## **HISTORIC PRESERVATION COMMISSION STAFF REPORT**

**Address:** 410 Randolph Rd., Silver Spring    **Meeting Date:** 12/06/11

**Resource:** Milimar **Report Date:** 11/29/17  
**Individually Listed Masterplan Site**

**Proposal:** Alterations to rear addition

1 PROPOSED REAR ELEVATION  
AOB3 3 1/16" = 1'-0"

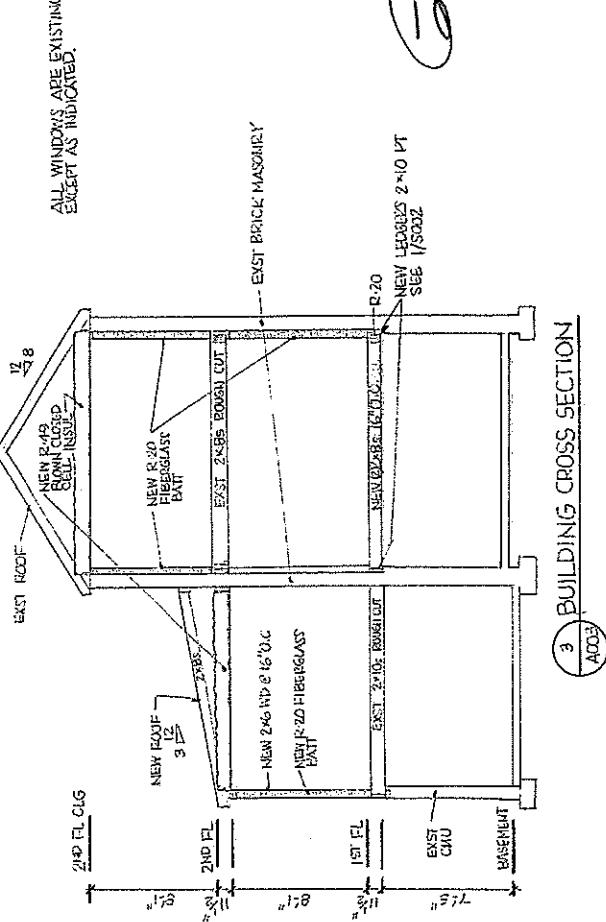
which requires substantial work. The applicant proposes removing all of the external structure on the first floor of the addition to the right and reconstruct it, recladding all of the addition with Hardi siding. French doors will be installed in place of the paired window, and a shed roof that matches the roof line of the addition to the left will be constructed. The roof for both additions will get a new asphalt shingle roof. Staff believes that this new unified rear addition meets the Standards and Chapter 24A and recommends approval.

The proposed changes to the rear will not have a significant impact on the historic character of the house. The proposed roof form will help to shed water away from the house and create a unified appearance of the rear additions. After this work is complete the additions will still be substantially differentiated enough to comply with Standard 9. The proposed French Doors and "Juliette" balcony are contemporary features; however, they will not detract from the historic character of the house (per 24A-8(b)(2)). The new asphalt shingle roof will replace the material that is currently there with an in-kind material. The new roof slope requires that this material be reviewed in its new orientation. Staff sees this as a compatible material and supports its approval.
